CITY OF ALBUQUERQUE

**RE: Meineke
5901 Carmel Ave. NW
Grading and Drainage Plan
Engineer's Stamp Date: 01/07/21
Hydrology File: C18D049**

MEINEKE
5901 CARMEL AVE N.E.
ALBUQUERQUE, NEW MEXICO

SHEET TITLE
GRADING PLAN
SHEET NO: **C-1**

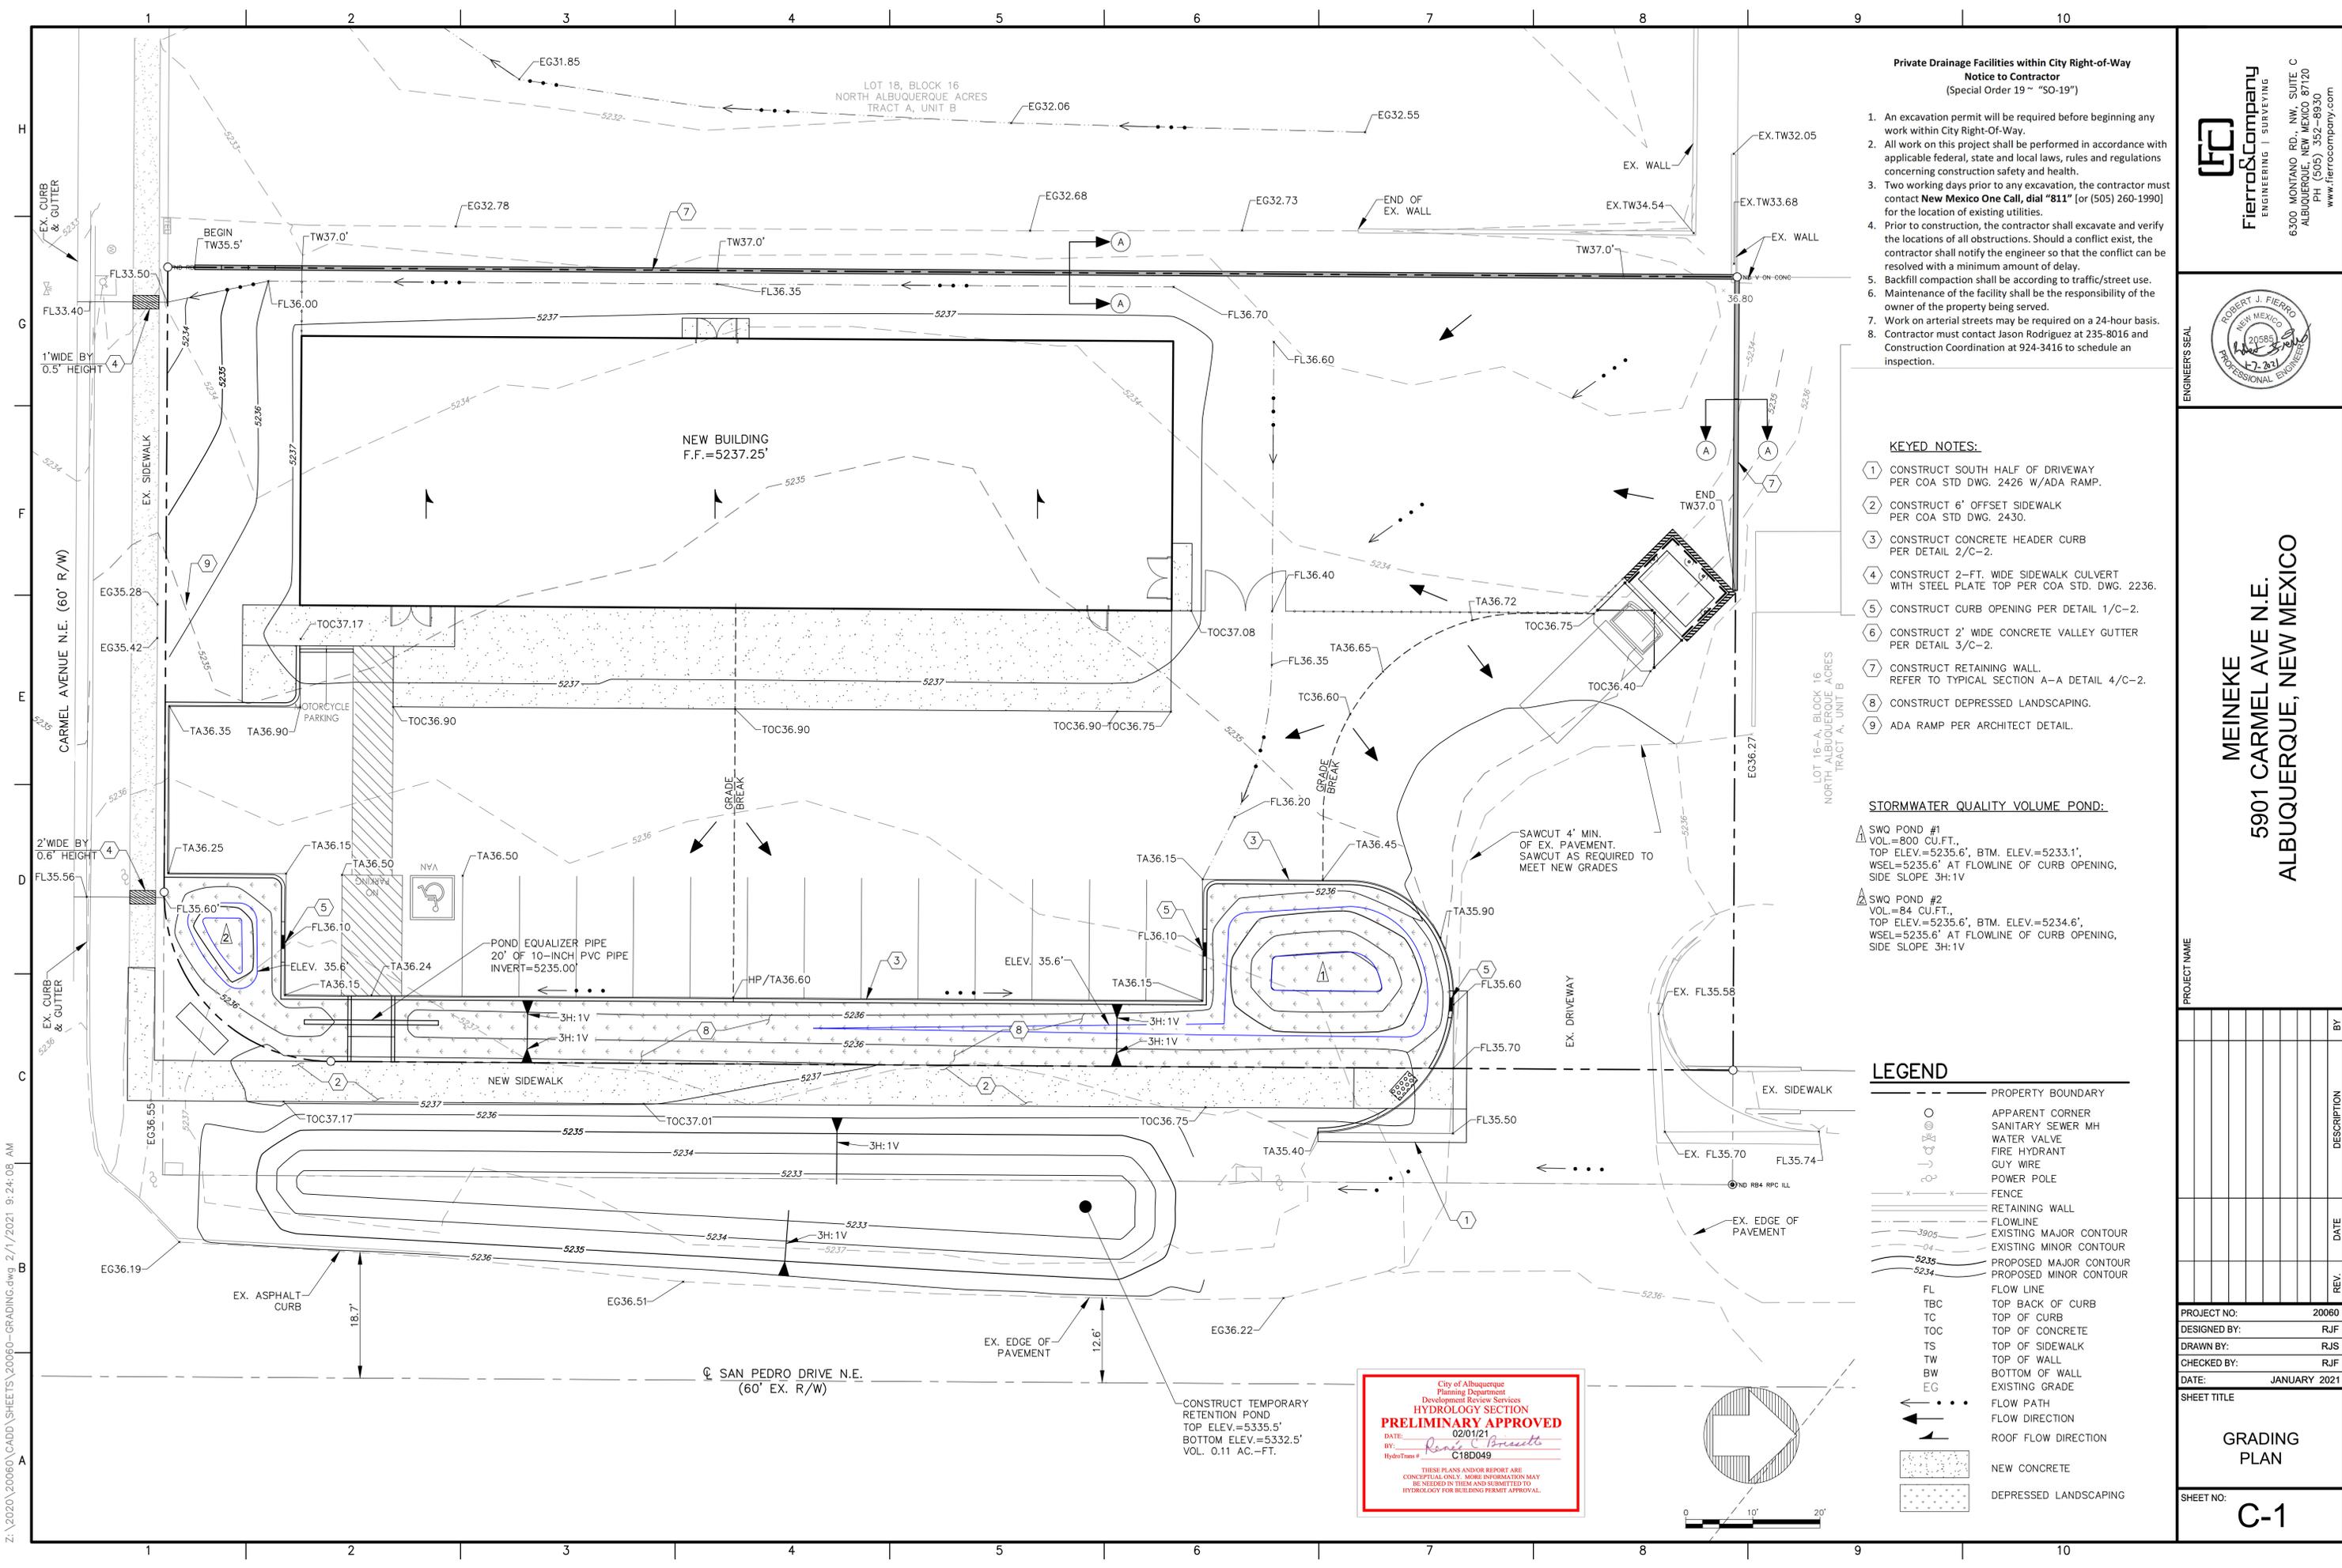
Based upon the information provided in your submittal received 01/07/2021, the Grading & Drainage Plan is approved for Grading Permit. As per our phone conversation on January 28, 2021, once the pond is removed from the R.O.W. and a Type A inlet installed with an 18" storm pipe to the existing MH and the waterblock is installed at the driveway, then please submit the drawings for Building Permit.

City of Albuquerque
Planning Department
Development Review Services
HYDROLOGY SECTION
PRELIMINARY APPROVED
DATE: 02/01/21
BY: *Renee C. Brissett*
HydroTrans # C18D049
THESE PLANS AND/OR REPORT ARE CONCEPTUAL ONLY. MORE INFORMATION MAY BE NEEDED IN THEM AND SUBMITTED TO HYDROLOGY FOR BUILDING PERMIT APPROVAL.
